Town Water Supply Bores

Review of casing condition

Warrumbungle Shire Council

22 May 2023

Figure 1 Selected imagery – Baradine Main production bore

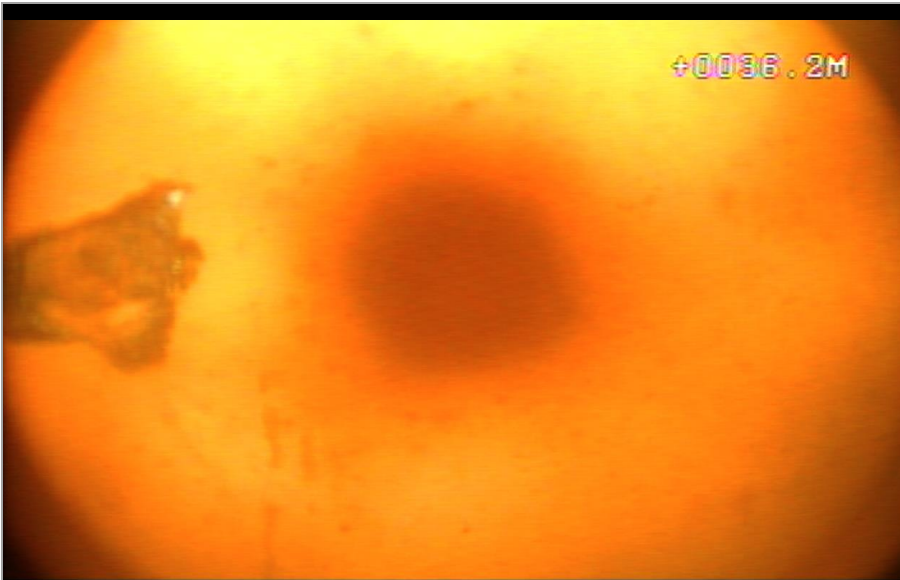
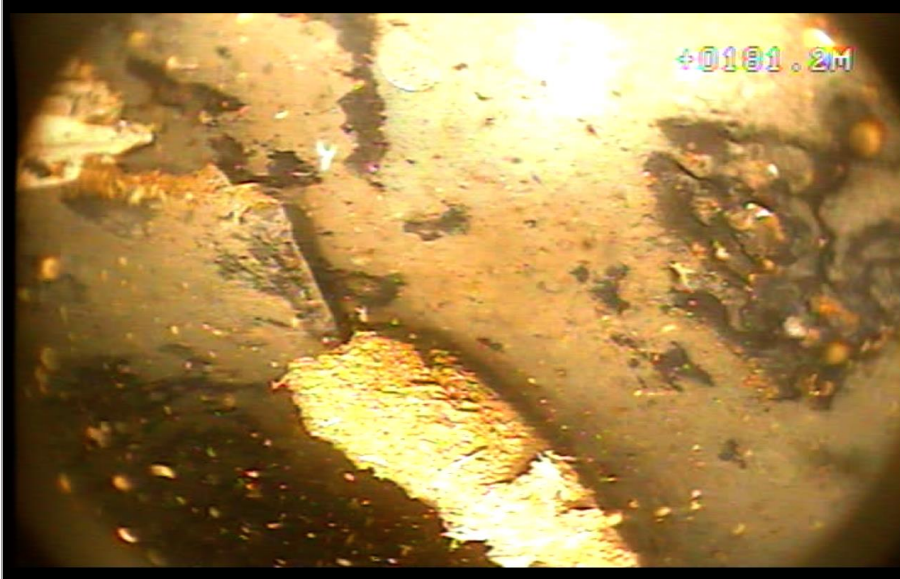
Example of a casing joint and relatively high quality imaging. Note suspended particles.

J-Latch has been partly damaged, likely through passage of drilling rods through this zone.

<p>Appears that casing at 188 m has been corroded through. This is part of the section telescoped inside the pressure cemented pumphouse casing.</p>
	<p>Plasma cut vertical slots. Note 'foreign pipe' still present.</p>
	<p>Slot apertures at greater depth are in reasonable condition.</p>

The casing does appear to be partly compromised in the area of cross-over, where the DN150 production casing has been suspended inside of the pressure cemented DN200 casing. However, this will not significantly effect the short term operation of the production bore. Consider that the Baradine Back-Up bore is 40 years older and still operational (albeit in a poorer condition).

The top of the j-latch appears to be partially bent, however, there appears to be sufficient clearance through this zone. Furthermore, approximately 30 m of pipe has been lost down the hole. Care will need to be exercised when drilling contractors enter this area of the bore, or with future inspection works.

Unless there has been a deterioration in the bore performance (flow rate / drawdown and physico-chemical) which are other indicators of potential casing issues, the recommended approach for this bore is:

- Decontaminate / pressure wash drilling / work-over plant mobilised to the site
- Mechanical scrub / brush the bore with nylon mandrels
- Air-lift development
- Apply chemical treatment and disinfection
- Air-lift development
- Undertake a specific capacity test
- Implement monitoring program to assess future maintenance actions

Figure 2 Selected imagery – Baradine Back-up production bore

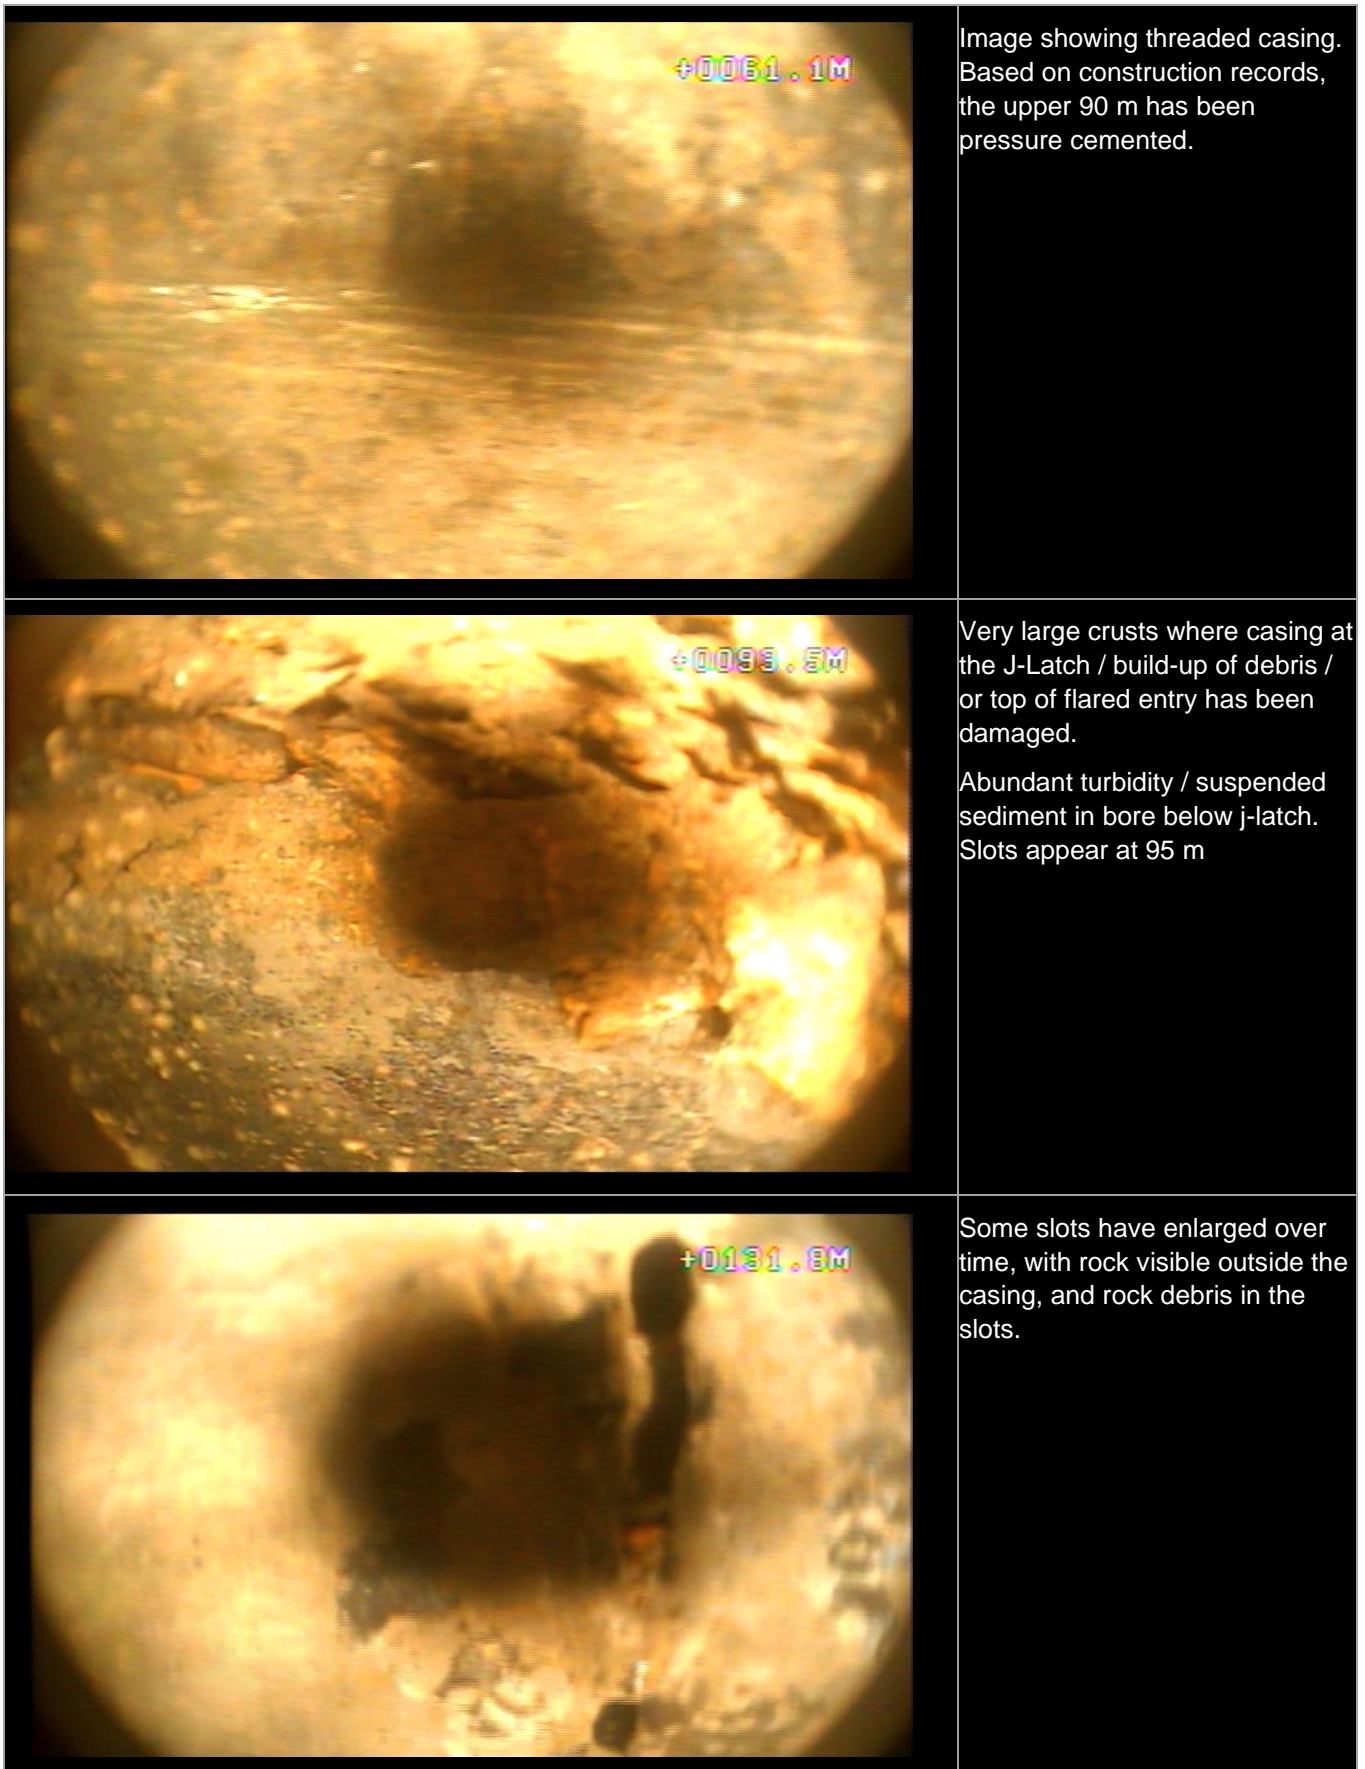
- High surface roughness in the splash zone of the bore, i.e. when water levels are drawn down through pumping. The drawdown in the bore is unknown and therefore an understanding of the splashing is not known.
- Cable ties were on the water table. These may have been dropped into the bore during pump installation and retrieval.
- Abundant suspended material in water and poor picture quality directly below water level / splash zone.
- Some areas of deep pitting / roughness e.g. 54 m, 80 m to 90 m
- Many of the slots have been enlarged
- Many areas of the DN150 with scaling and pitting

The Baradine back-up bore is a 55 year old steel cased bore which is beyond its service life. It is not known how often the bore is operated by the Council or its significance to the town water supply system and this predicated the discussion on the management actions for the production bore below.

This bore should be decommissioned and replaced with an inert cased bore to provide long term security of supply to Barradine township. However, there may be an opportunity for Council to defer the replacement, subject to their risk appetite, i.e. continue to operate the bore and monitor its performance for possible signs of failure. This may provide time for Council to plan and budget for its replacement.

Figure 3 Selected imagery – Bugaldie production bore

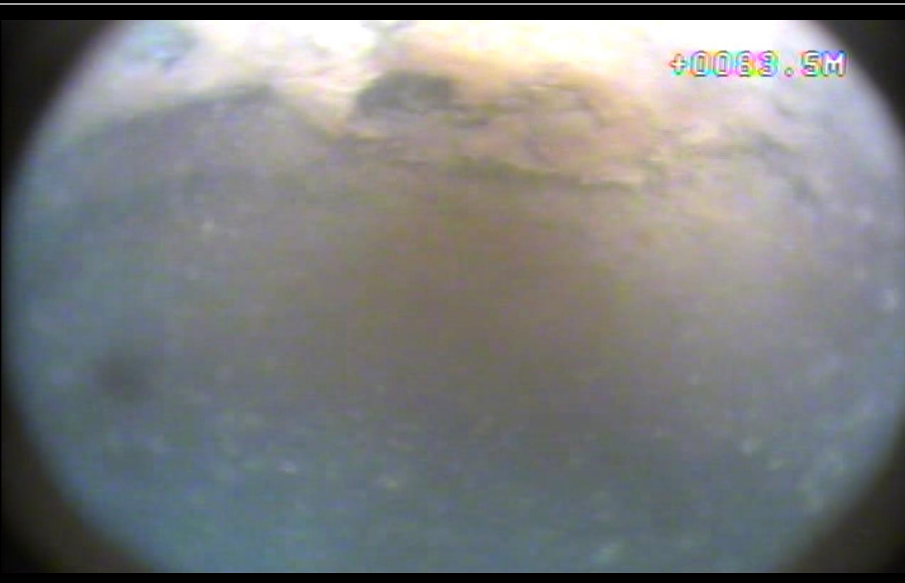
This bore is over 90 years old with a very deep water table, and therefore it is not unexpected that the upper 70 m or more are in a poor condition, i.e. the merit in undertaking an inspection could have been considered questionable. Interior surface had considerable roughness and scaling. However, it is noted that the bore develops a relatively competent sandstone and therefore the casing is arguably present to ensure that production pumps can be safely installed and retrieved from the borehole. However, installing the pump at a depth outside of this casing removes this protection.

<p>Discoloured scaling on surface of casing. Poor visibility below water table.</p>
	<p>Bottom of the steel casing</p>
	<p>Example of image quality in the open hole section of the borehole.</p>

ASC Equip (2022c) have identified holes in the casing which could lead to a risk of gravel / sand intrusion into the borehole or catastrophic bore collapse. They have recommended the bore be resleeved. In consolidated rock the risk of sands and gravels entering the bore through holes could occur if fretting occurs overtime, however, the rock must be reasonably competent given that it has remained open since construction.

Most drilling contractors would prefer to drill a replacement bore as this minimises the construction risk of entering aged steel casing which could be fragile, and potentially unable to withstand the rigors of heavy drilling plant. Another key benefit of drilling a new bore is that it would enable appropriate surface seals to be installed to protect the production aquifer from surface infiltration. Hence it is GHD’s recommended approach.

Figure 4 Selected imagery – Dunedoo production bore

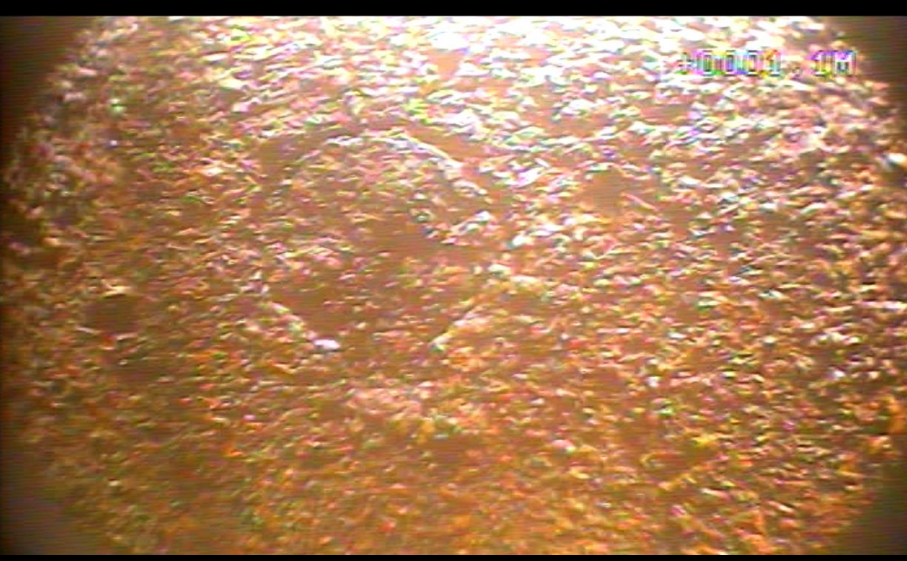
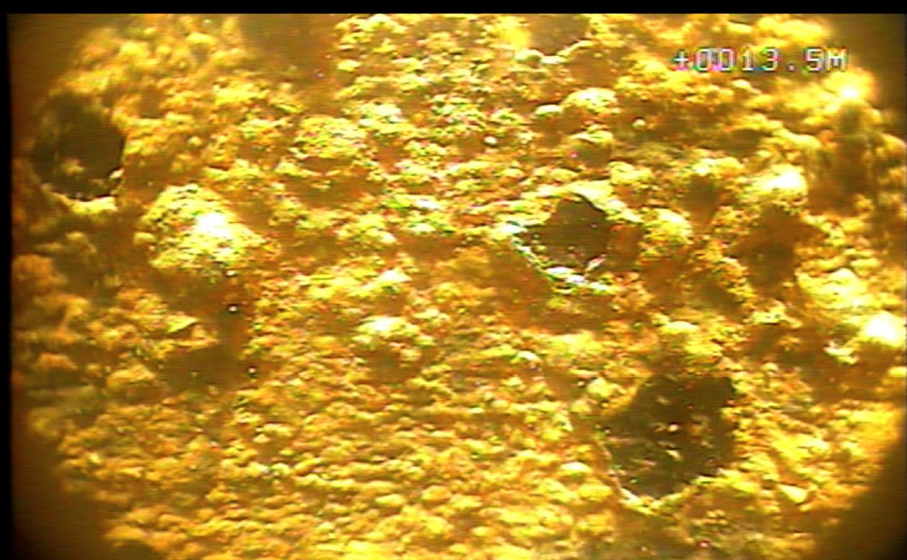
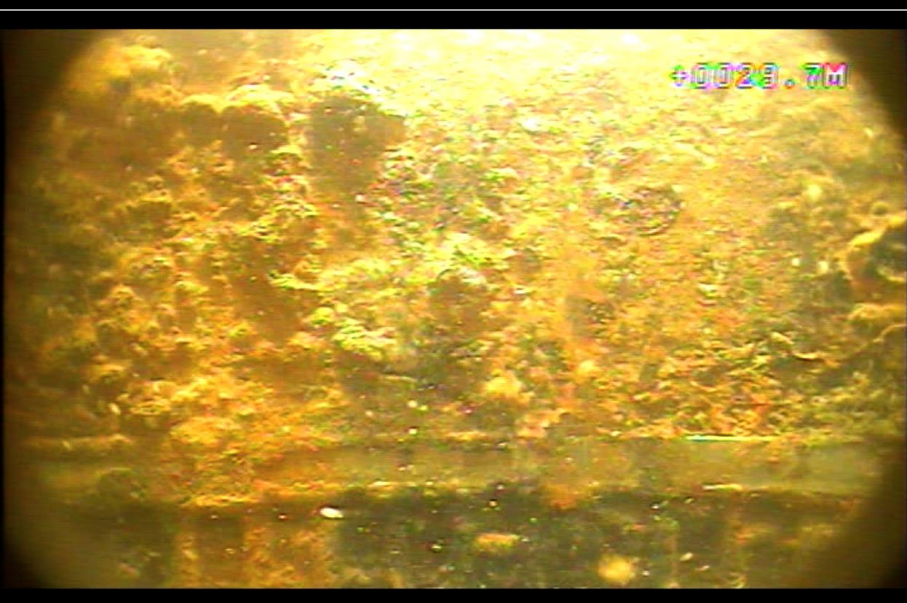
ASC Equip (2022d) have identified a potential parting in the casing, and areas of dark discolouration which were noted as being holes.

<p>Such marks were noted at multiple locations in the casing. It is interpreted that these are torch cut holes that were used to elevate the casing into position. The lugs are then hammered back into position and welded. These represent high risk areas for corrosion and ingress of fines into the bore. They result from poor drilling practice – the use of lugs ('dog ears') attached to casing exterior or collars is preferred.</p>
	<p>Casing has considerable crusts formed on the exterior surface. Darker areas could be where the crusts have been knocked by retrieval of the production pump.</p>
	<p>Severe precipitates / crusts forming – high risk area for corrosion (bimetallic) due to welding mild steel casing to stainless steel.</p>

At this depth, it would seem far more reasonable (and economically comparable) to construct a replacement bore, using inert casing materials e.g. Class 12 PVC (or the more expensive stainless steel), and continuous slot stainless steel screens. The bore construction should be consistent with NUDLC (2020) guidelines and include formation sampling to accurate size bore screen apertures. Another benefit of the replacement bore drilling is that appropriate annular environmental seals can be incorporated into construction to provide greater wellhead protection and water quality security. Hence, this is GHD's preferred approach to managing the bore.

- Developing the sediment from the bore and exposing the full screen interval and bore sump
- Mechanically brushing the bore to remove encrustations
- Chemical treatment to remove biofouling and scales
- Completing a specific capacity test on the bore (short duration pumping test).

Figure 5 Selected imagery – Kenebri production bore

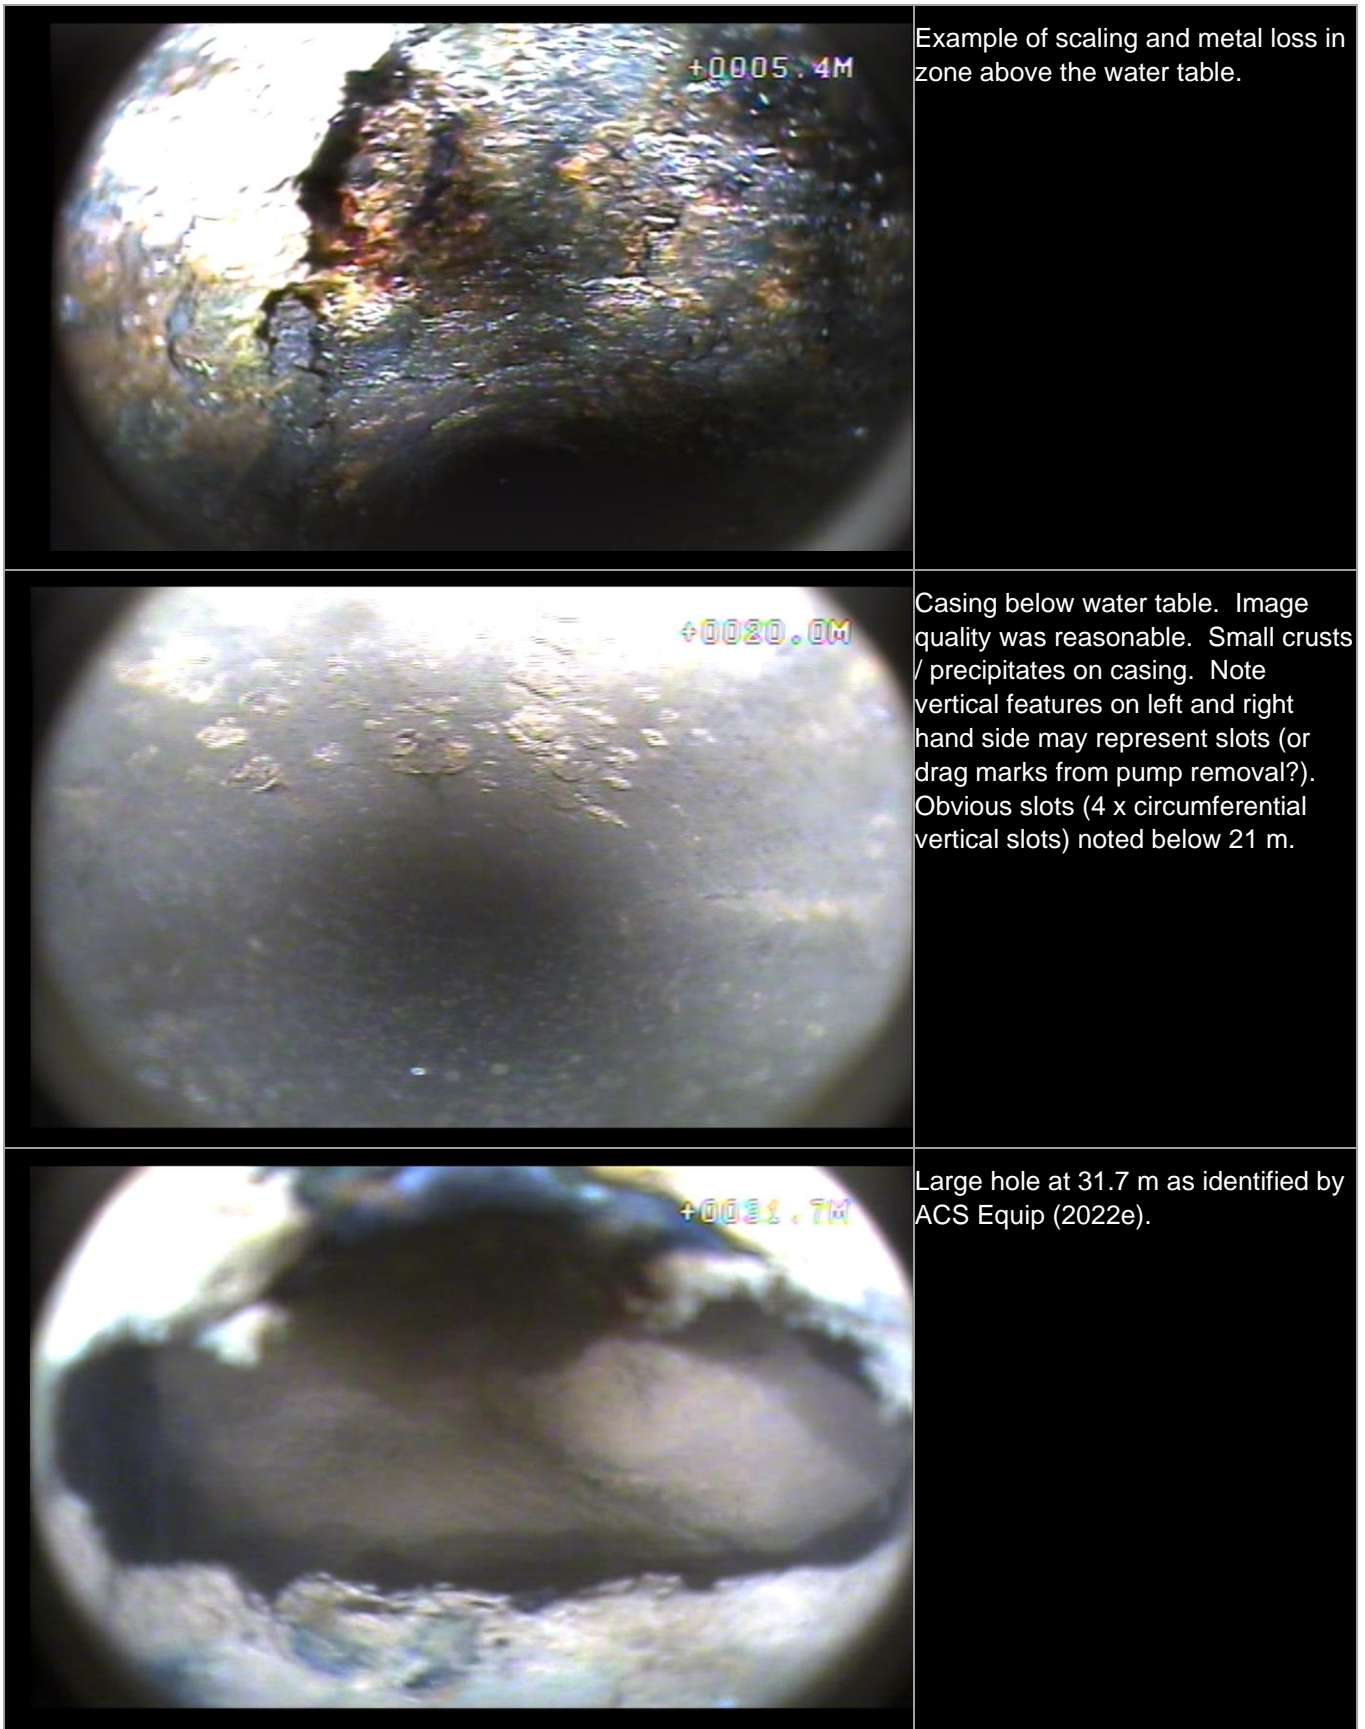
- Significant, obvious scaling and metal loss in the zone above the water table.
- Image quality below the water table and splash zone was reasonable and the casing interior surface exhibited less rugosity / roughness.
- Slotted sections were difficult to differentiate as in some areas the slots were heavily encrusted.
- Heavily scaled at 23 m, however, no sediment or increased turbidity was noted.
- Duct tape and other debris identified at 34 m.

GHD agrees with the assessment made by ASC Equip (2022d) that the bore is in poor condition and represents a significant risk to Council because:

The recommendation of ASC Equip to resleeve the bore with a stainless steel swage is not supported. Swaging steel in the condition identified is considered to constitute a significant construction risk as the swaging process could result in further bore failure. Furthermore:

This bore should be decommissioned in accordance with the NUDLC (2022) guidelines and a replacement bore drilled, consistent to the same standard. The replacement bore design should include:

- Inert casing materials, e.g. Class 12 PVC is sufficient for this bore depth
- Continuous slot, wire would stainless steel screen.
Such screens have a greater open area and with considered bore design, e.g. appropriate sizing of apertures and gravel packing, should result in a more efficient bore, i.e. less drawdown for the same flow. This would necessitate formation sampling and sieve analysis during the drilling program to size screens.
- Bore headworks erected with a concrete slab to support valving, metering and associated equipment e.g. sampling ports, electrical panels.
- Wireline logging, e.g. natural gamma may assist in identifying a screen zone for the bore.
- Pumping test to enable sizing of an appropriate production pump (and determine a specific capacity baseline).
